Office Action Summary

10/591,627

SCHWENDEMANN, FRANZ

DETAILED ACTION

Figure Y: View of supporting member within rotor drive in the device of Frey et al.

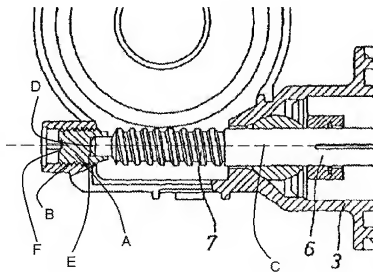
- Rotor (6) positioned with bearings (see bearings near 6 and 14 in Fig. 1) in a housing (Fig. 1)
- Rotor being supported with at least one front face (18) axially on a supporting member (34), which is attached via a form closure on the housing
- Supporting member (A; see Figure Y below) having radial crosspieces (see paragraph [0029], lines 8-10) that can be turned into the housing (3) thereby creating chamfers (Frey discloses the supporting member as a set screw with an external thread, see paragraph [0029], lines 8-10, which is commonly known in the art to be capable of turning into a housing and creating chamfers as described in the specification)

- Supporting member having a cylindrically shaped base plate (at A; see Figure Y below) having its own cylinder axis (C; see Figure Y below) wherein the base plate has an outer circumference where crosspieces (B; see Figure Y below) are arranged in a plane approximately vertical to the cylinder axis (see crosspieces in planes approximately vertical to the cylinder axis C in Figure Y below)

- Crosspieces (B) are arranged in several planes, which are axially spaced in intervals (see Figure Y below)

- Front face of the rotor has a radius (D; see Fig. Y below) that rests against a flat stop surface (E; see Fig. Y below) that is formed on the supporting member

Frey et al. discloses the advancement of the supporting member (see paragraph [0029] lines 8-14) as well as a notch-like feature (F; see Figure Y below) formed on the support member which is deemed to be a form closed entrainment member.

13. Claims 20 and 24 are rejected under 35 U.S.C. 103(a) as being unpatentable over Frey et al., US PGPub 2004/0012280 in view Adams, US Patent 5,000,637. Frey et al. discloses substantial claim limitations (see 102 rejection above), including an attachment area for the supporting member (at B in Figure Y above) but does not disclose the following, respectively:
